Note: This document reports on the status of ETRTO WG on Rolling Resistance and also provide an analysis of Russian Federation presentation to GRRF 57th Informal Document No. GRRF-58-10 on Rolling Resistance.

3. Comments on Pr Petrushov document and figures.

Informal document N°GRRF-58-10

Presentation to GRRF 57th and Informal document No.GRRF-58-10

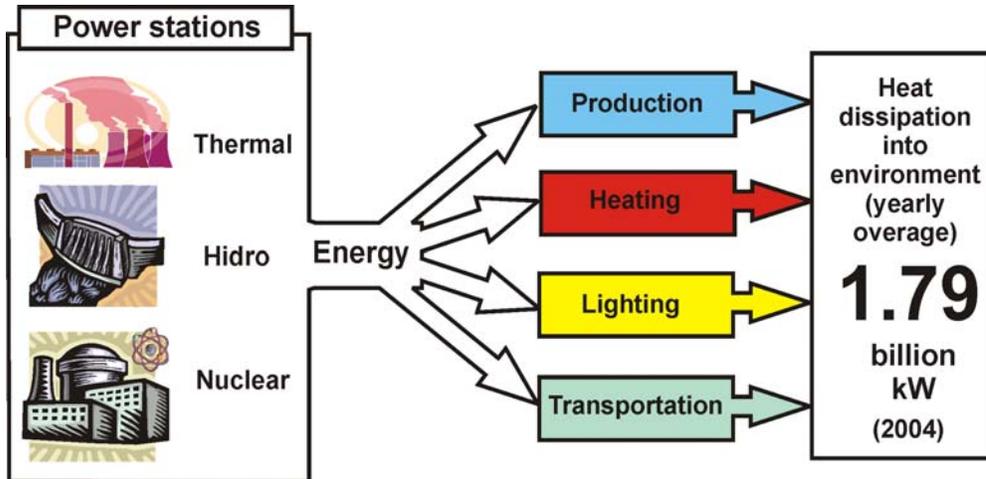
Considering that about 1.1 billion tyres were built worldwide in 2003, it is likely that the figures are correct and that about 3.9 billion tyres are currently in use on the planet.

2.67 million km for 3.9 billion tyres correspond to a mean tyre diameter of 0.685 m, which seems correct.

Knowing that the Earth to Moon mean distance is about 384 000 km, 2.67 billion km correspond to about 7 times this distance, and not 19 times as written in the document.

Knowing that the Earth equator's perimeter is about 40 000 km, 2.67 billion km correspond to nearly 67 times this perimeter, while the documents quotes 66, which is simply a different rounding.

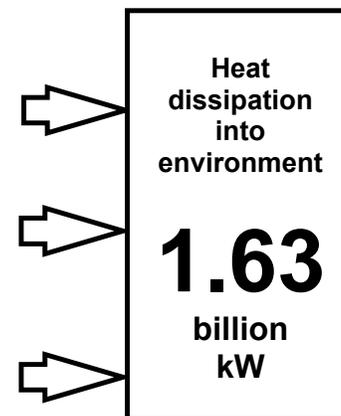
This slide contains a lot of information.

First of all, the title speaks about the industry and the figure shows only power stations. But industry also uses energy of other kinds than electricity. So it is a bit difficult to understand what lies exactly behind the figures.

On the second hand, the compared figures are power magnitudes, expressed in Watts. But what warms the planet is not power but energy, which is power multiplied by time.

Even we admit the data here both for power station and tyres, vehicles are operated a small proportion of time : about 2 or 3% for passenger cars, for instance, while nuclear power stations are operated nearly 100 % of time. This makes a 30 to 50-fold difference. In this way of thinking, I found the total energy produced/consumed in 2002 : 10 G toe or about 430 million TJ (source : Pocket Book Energy and Transport in figures - DGTREN 2004 – page 2.8.1).

I then computed the energy dissipation by the tyres with the Russian figures for CRR and tyres numbers and the following other estimates :

PC tyres : mean load : 300 kg ; mean annual distance : 15000 km
 LT tyres : mean load : 1000 kg ; mean annual distance : 30000 km
 CV tyres : mean load : 3000 kg ; mean annual distance : 70000 km.

The total annual energy dissipated by the tyres is then about 8 million TJ, less than 2% of the energy produced.

In consequence, the warming effect of rolling tyres and industry are not, and by far, comparable.

As shown above, this comparison has no sense since the vehicles are operated only a small part of time while most power plants are operated a much more significant fraction of time.

**Typical energy diagram for region/country
Power of automobile fleet action on environment.**

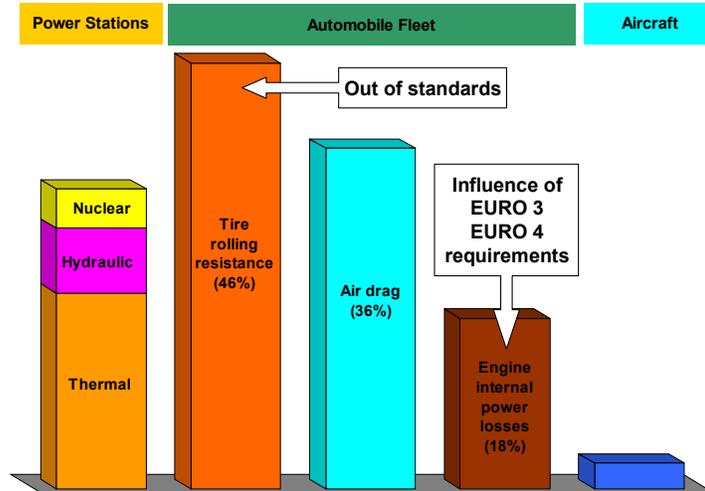
In this slide, the power dissipated in tyres is roughly 30% higher than the electricity produced, which does not seem consistent with the content of previous slide.

In addition, the aerodynamic drag is much lower than the influence of RR. This corresponds to a very low vehicle speed. We do not know its representativeness.

Moreover, the EURO engine requirements apply to all the energy consumed by the vehicle, including engine and transmission frictions, aerodynamic drag and tyre RR.

Finally, the thermodynamic yield of an engine is, at best, 30 to 40% according to its technology. The 18% quoted in the slide must correspond to transmission losses while engine losses are much higher.
